**Subject:** Submission for DA2019/1260 "Daily Traffic Congestion".

RE- Proposed Seniors Development 27&29 North Avalon Road, North Avalon.

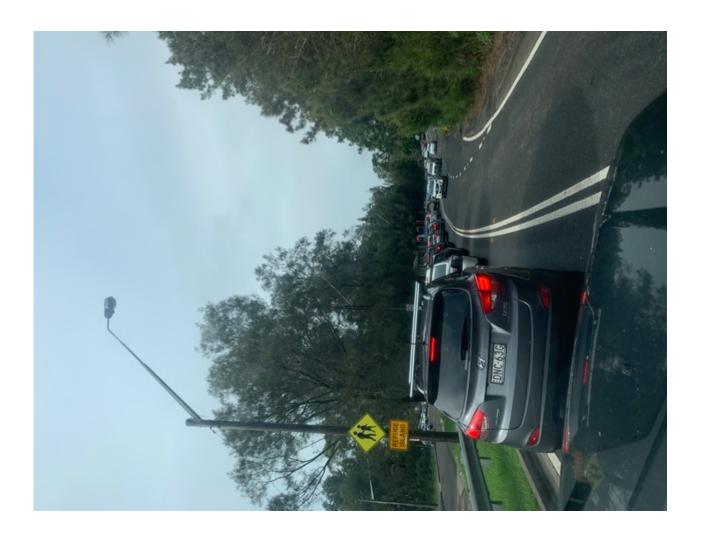
This is a direct statement taken directly from the prepared Traffic Assessment Report-

\*Please note this assessment was for the period between 7-9am and 4-6pm inclusive.
